Recall Bulletin

02V-253

SUBJECT: 02039 – REARWARD FOLDING HEAD RESTRAINTS PINCH POINT

**MODELS: 2000-2002 CHEVROLET TAHOE
 2000-2002 GMC YUKON
 2001-2002 GMC YUKON DENALI
 2002 CADILLAC ESCALADE**

931267

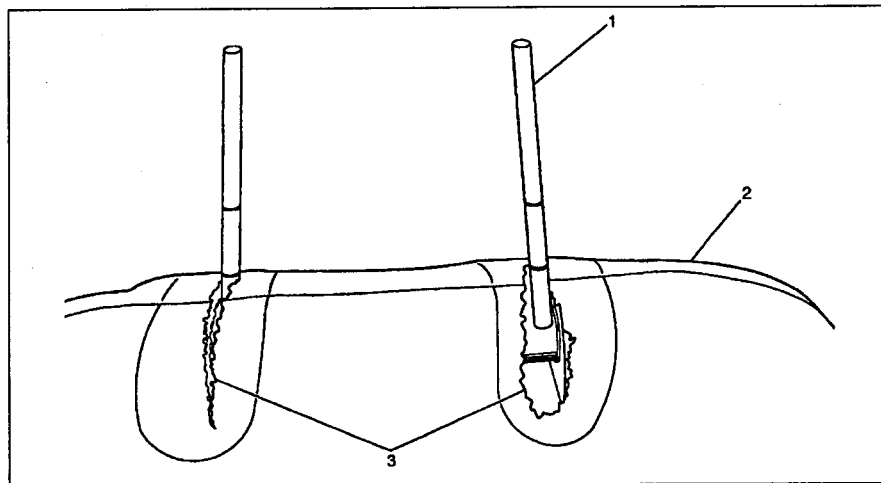
4. Insert an awl or pointed tool into the small hole (1) in the retainer located at the bottom of the head restraint while slightly pulling upward on the restraint. Repeat this step on the second support of the head restraint.
5. Remove the head restraint.

922587

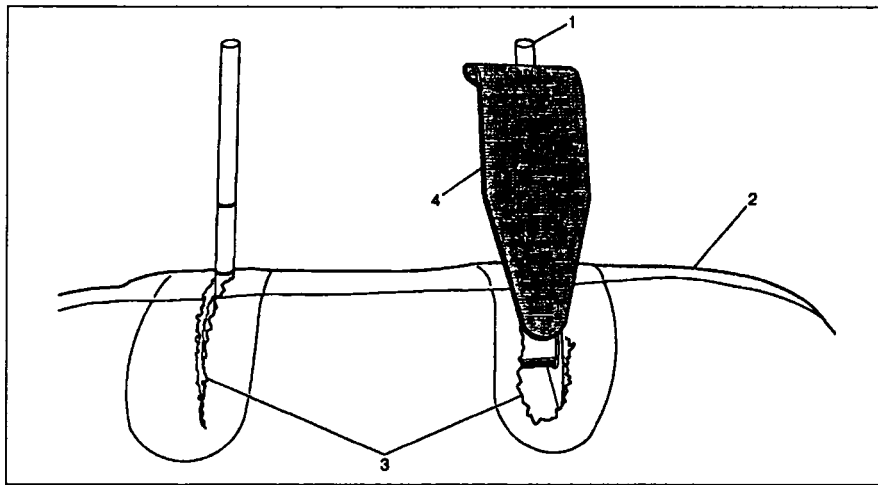
6. Raise the head restraint supports (1) to a vertical position and carefully open the slit (3) in the seatback fabric (2). The illustration shows the left slit being closed and the right slit when open.

922588

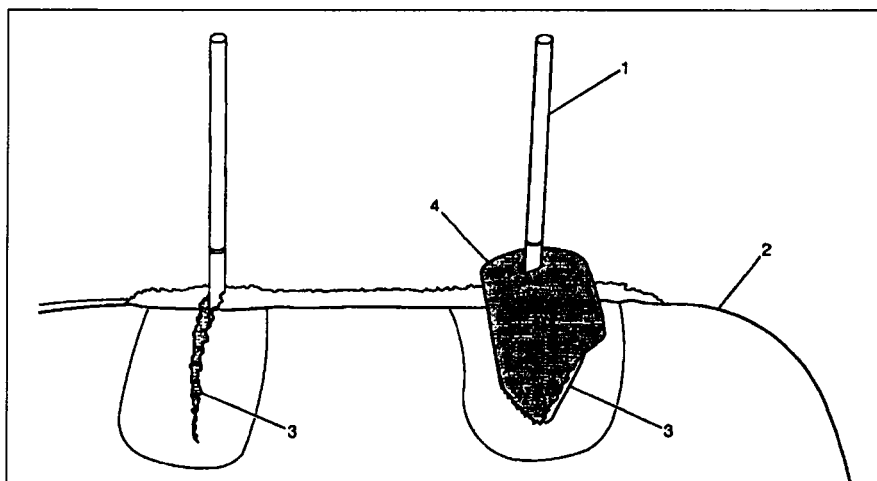
7. Install one support cover (4) on the head restraint support (1) with the support going through the hole in the cover.

922590

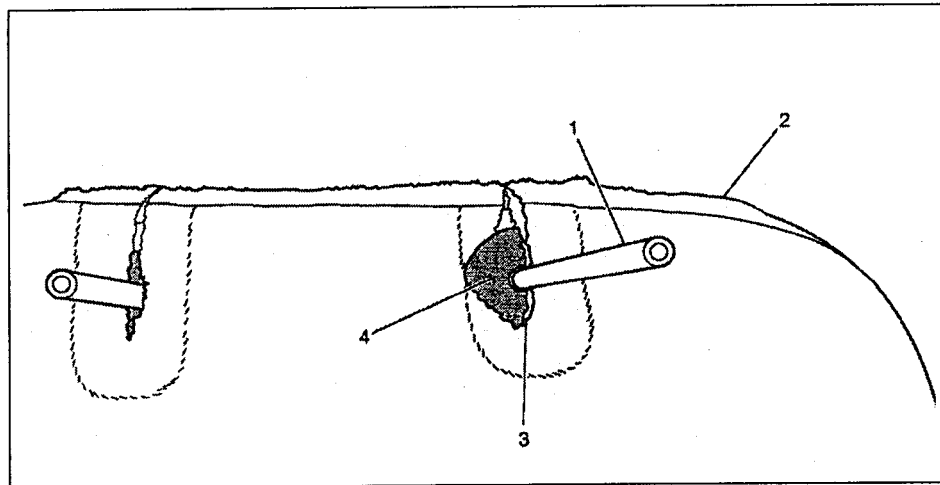
8. While holding the slit (3) in the seatback fabric open, begin sliding the cover down inside the seatback as shown.

922591

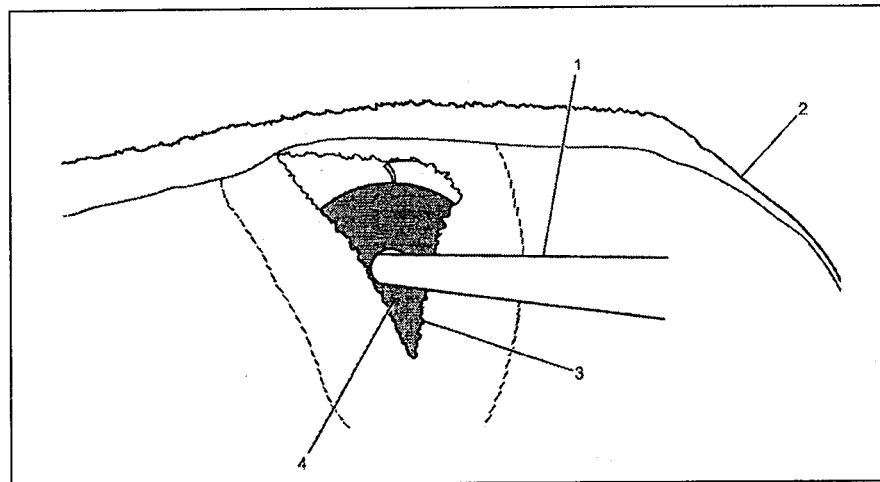
9. When the support cover (4) is all the way down on the head restraint support (1), fold (tilt) the head restraint support rearward as shown.
